# California Independent System Operator

## Comments of the California Wind Energy Association and American Wind Energy Association on the CAISO Straw Proposal on Reactive Power Requirements and Financial Compensation September 3, 2015

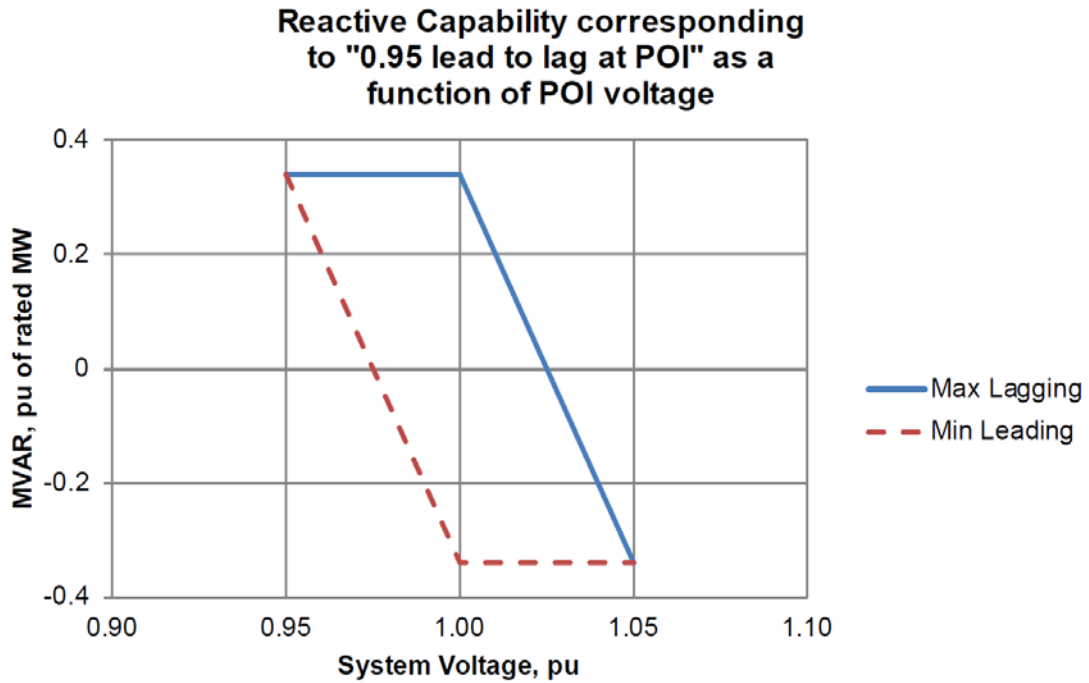
- Agreeing with CalWEA/AWEA at the stakeholder meeting of August 3, 2015 that the reactive power capability curve requirement for an asynchronous generator (Figure 2 of the Straw Proposal, shown below) should be based on “actual MW” output and not “rated MW” output.<sup>1</sup>

<sup>1</sup> CAISO agreed to make this correction in the next version of its proposal.
